UNITED STATES
NUCLEAR REGULATORY COMMISSION
ATOMIC SAFETY AND LICENSING BOARD PANEL
WASHINGTON, D.C. 20555

SUBJECT: PACIFIC GAS & ELECTRIC COMPANY
(DIABLO CANYON NUCLEAR POWER PLANT, UNITS 1 AND 2)
DOCKET NOS. 50-275-LR and 50-323-LR
ASLBP NO. 10-890-01-LR-BD01
WRITTEN LIMITED APPEARANCE STATEMENT

Subject: NRC review of PG&E's report on the
Shoreline Fault offshore DCNPP, SOCAL

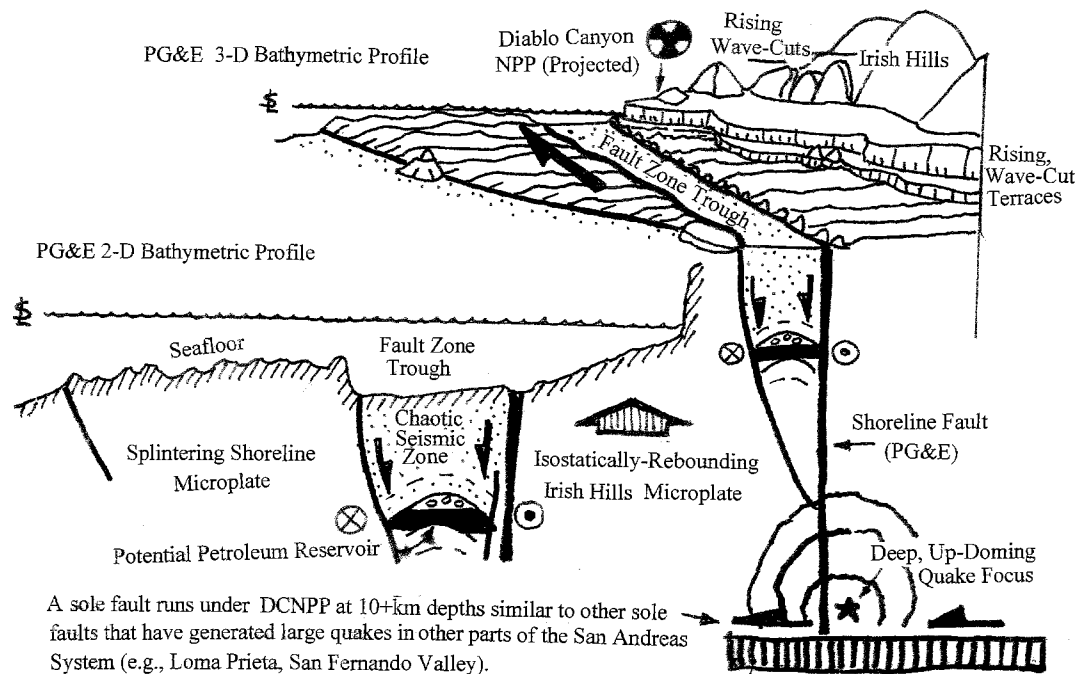
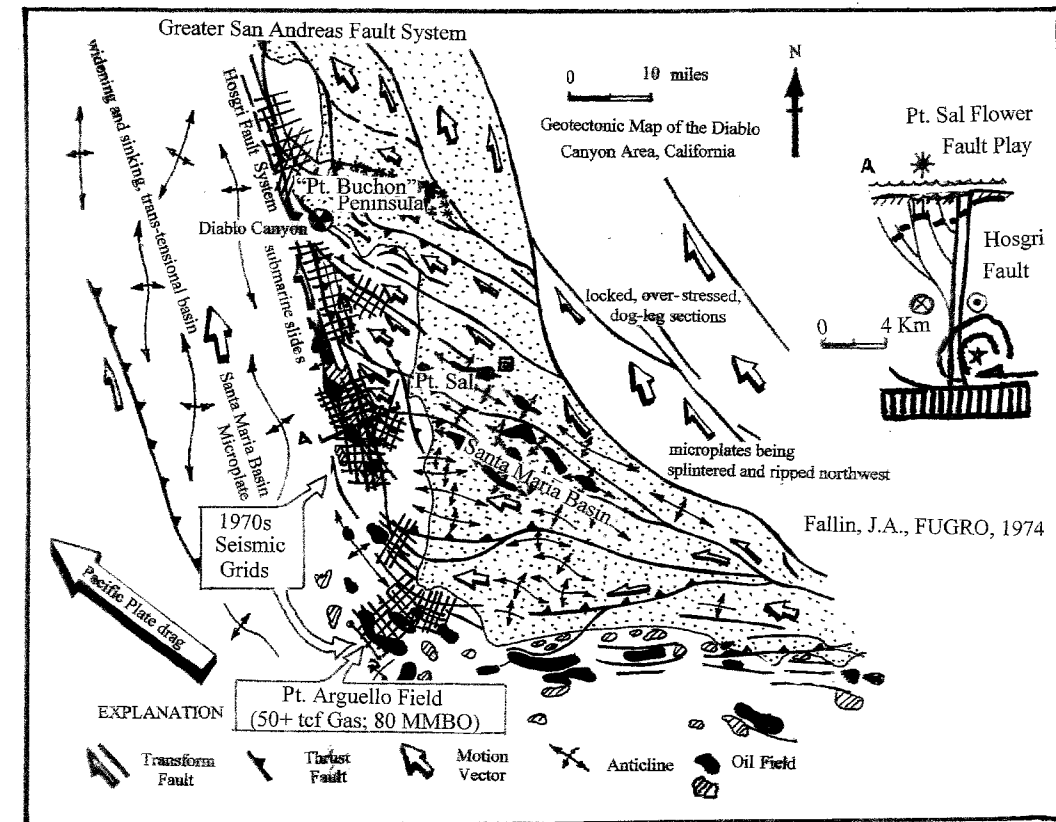
PG&E's 2012 bathymetric profiles of the Pacific seafloor around Diablo Canyon Nuclear Power Plant (DCNPP) suggest that up to a quarter-mile-wide trough borders what the utility company labels as the Shoreline Fault. Such troughs occur often over upward-flowering offsets in the Greater San Andreas Fault System, with some even flagging "pinched" or "torqued", anticlinal, petroleum traps at depth immediately south and southeast of the DCNPP along the Hosgri and other fault traces, including ones in Santa Maria Basin. Geochemical signatures suggest that thermally-mature, organic-rich,

A sole fault runs under DCNPP at 10+km depths similar to other sole faults that have generated large quakes in other parts of the San Andreas System (e.g., Loma Prieta, San Fernando Valley).

2010 "Bulletin of the Seismological Society of America" article entitled "Seismotectonics and Fault Structure of the California Central Coast"

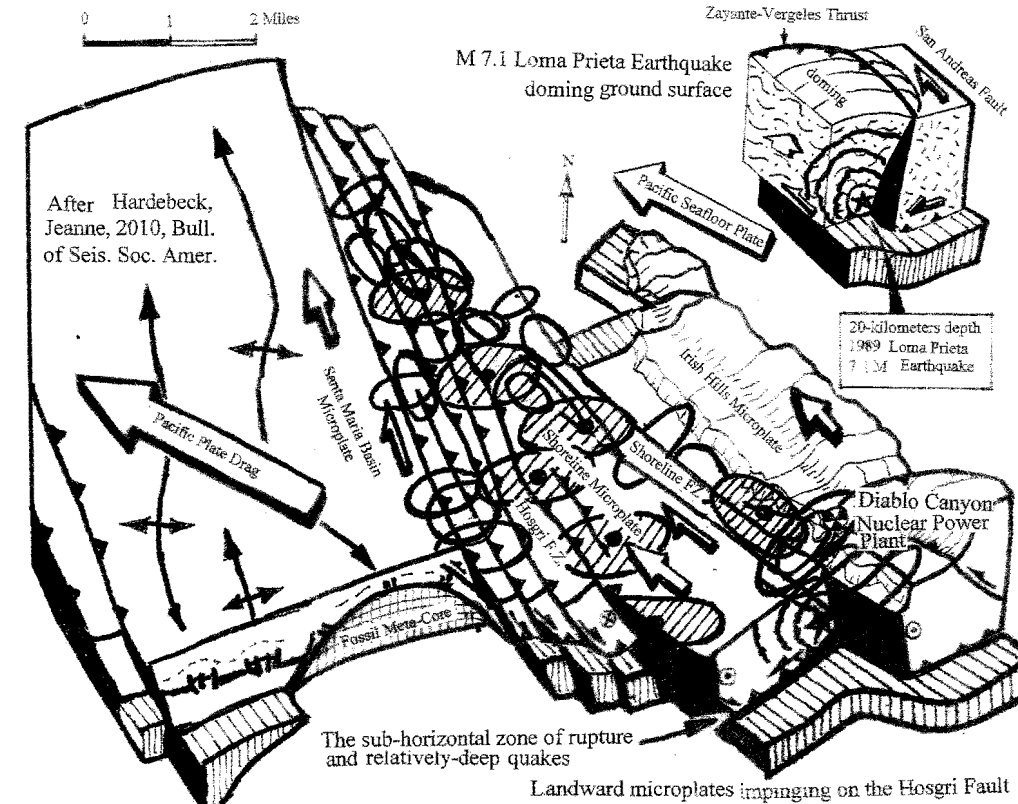
"Bulletin of the Seismological Society of America" suggests that an active sole fault runs below DCNPP between 10- and 12-kilometer depths. The sub-horizontal zone of rupture and intermittent, jolting, stress releases is defined by a series of relatively-deep, earthquake foci that occurred between 1988 and 2008 along the Shoreline Fault trace. Combined with a cluster of shallower, M 0.8 to M 3.5 seismic events, the deeper quakes accounted for an average of more than two tremors per year along the Shoreline Fault, while leaving open the possibility of even larger, more destructive earthquakes to come.

Such being the case, one must consider doming as well as fracturing of ground surface atop "sole fault" quakes in the DCNPP area. This is to say that even structurally-reinforced nuclear facilities might be tilted as well as fractured by sole fault shifts below them, cracking or partially draining used fuel rod cooling pools while also jamming reactors and initiating nuclear meltdowns. In 1989, the M 7.1 Loma Prieta Earthquake just south of the San Francisco Bay Area was generated at 20-kilometer depths over a sole fault, doming rather than fracturing ground surface, while also inducing numerous landslides and rippling Bay Area mud deposits like a bowl of Jello. Numerous, reinforced structures were tilted off their foundations as freeways overpasses collapsed like wet spaghetti and as broken gas main fires raged beside broken water lines.

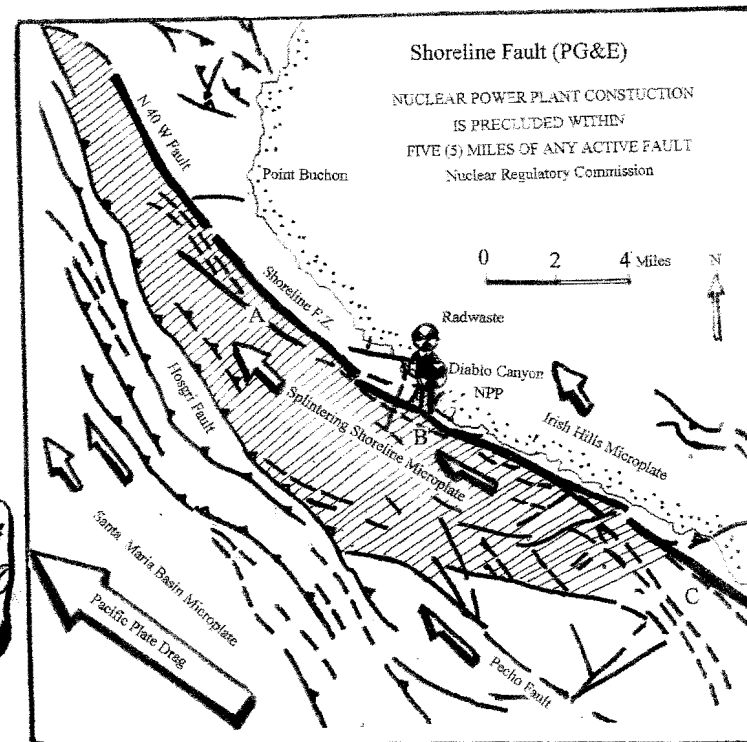
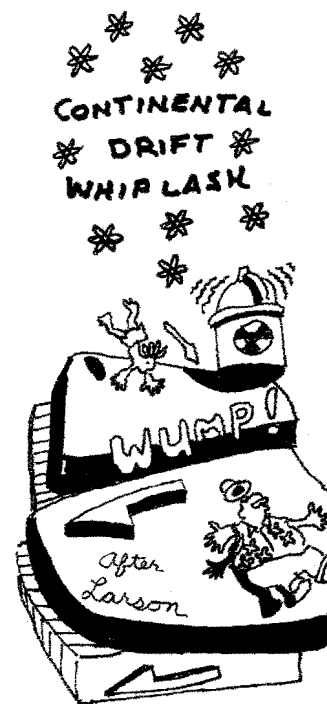
In PG&E's 2012 status report on the Shoreline Fault, the Utility describes the transform system as being actually three, out-stepping, seismically-active, right-lateral offsets that are less than 20-miles long combined. Then, after a rigorous evaluation with "logic trees", probability calculations and mind-numbing mathematics, the Utility concludes that the fault traces are no more than about M 6.5 "capable".

Others of us, using only logic, common sense and comparative analyses, view the Shoreline Fault a bit differently. To some of us, the Shoreline Fault is a series of three stressed, surface "rips" that may well be connected at depth and ready to tear apart with bounding "end" faults to the northwest (N 40 W Fault) and to the southeast (Oceano Fault), forming a 40- to 60-mile-long surface rupture. The fault is located in a stressed,
